SUBJECT: ADDENDUM NO. 2

Vallejo Station Parking Structure Phase A

(File Number 9866.14.02)

,,,,,,,,,,,,,,,,,,,,,,,,,,,,,,,,,,,,,,,	
Date: 02-12-10		WDI No:	00020	.345
Project: VALLEJO STATION PHASE A				
By: GENARO/JOSE				
Drawing Sheet or Spec: A1.1	Scale: 1/16" = 1'-0"			
CB No.: ADD No.2		Sket	ch No.:	02

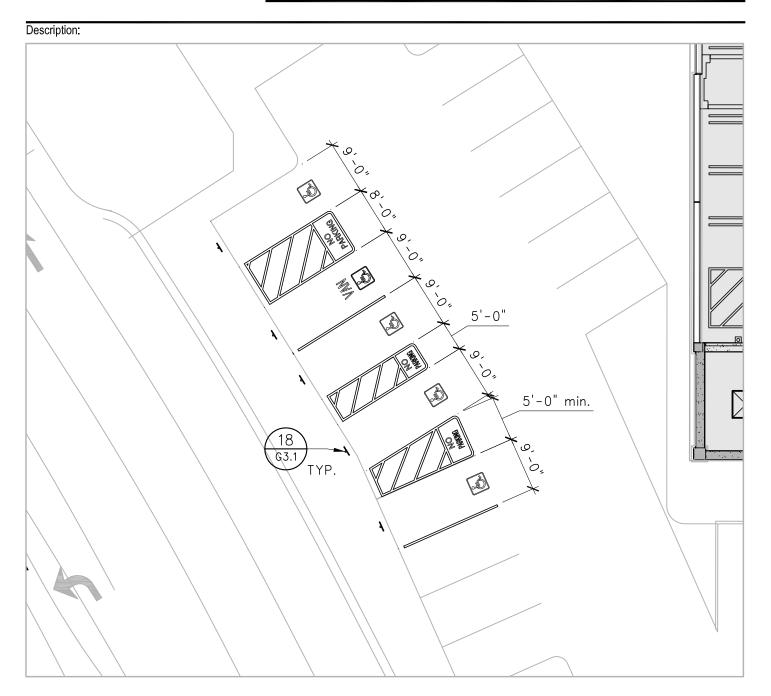
12. Reference SHEET A1.1, Site Plan

Revise the on grade parking entry at Mare Island per attached Sketch 2 to match Civil Plans.

CB No.: ADD No. 2 Sketch No.: 03

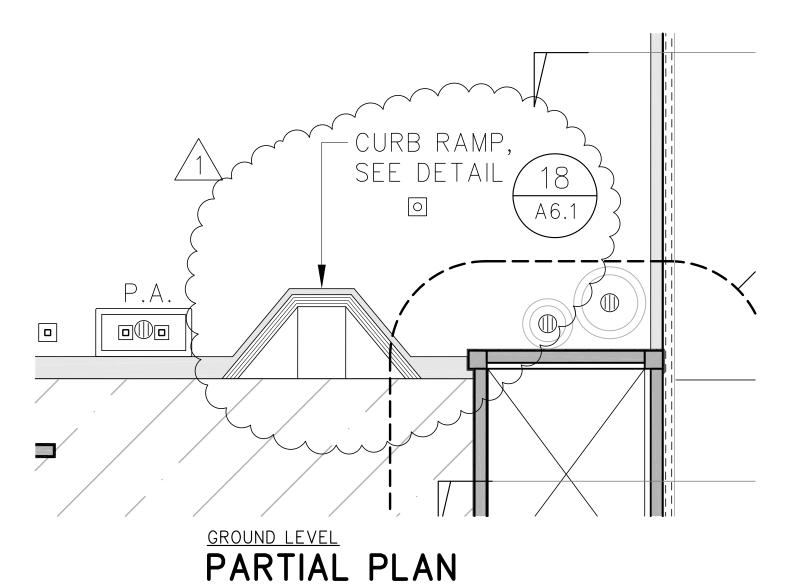
13. Reference SHEET A2.3, Ground Level Parking Plan

Add curb ramp at Paseo per attached Sketch 3.

Date: 02-12-10		WDI No:	00020.345
Project: VALLEJO STATION PHASE A			
By: GENARO/JOSE			
Drawing Sheet or Spec: A2.3D	Scale: 3/16" = 1'-0"

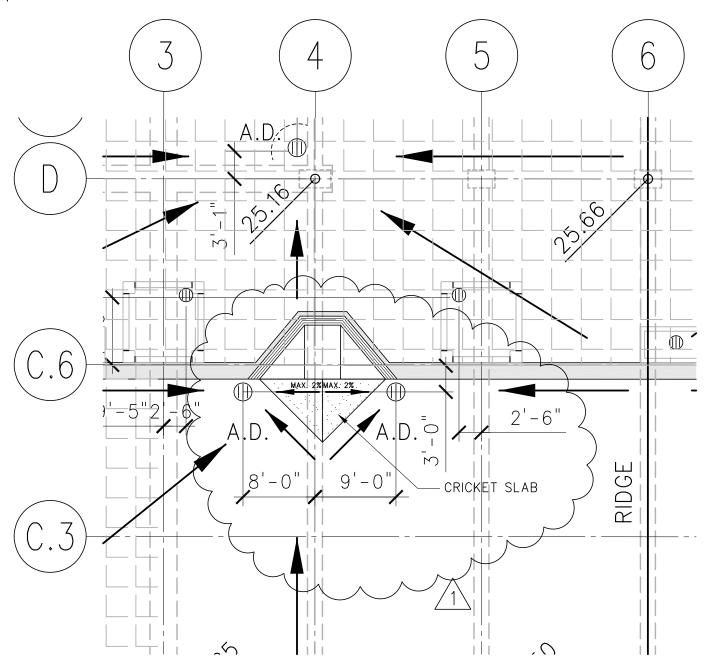
14. Reference SHEET A2.3D, Ground Level Drainage Plan

Revise and add area drains at curb ramp at Paseo per attached Sketch 4. Provide drain pipe accordingly.
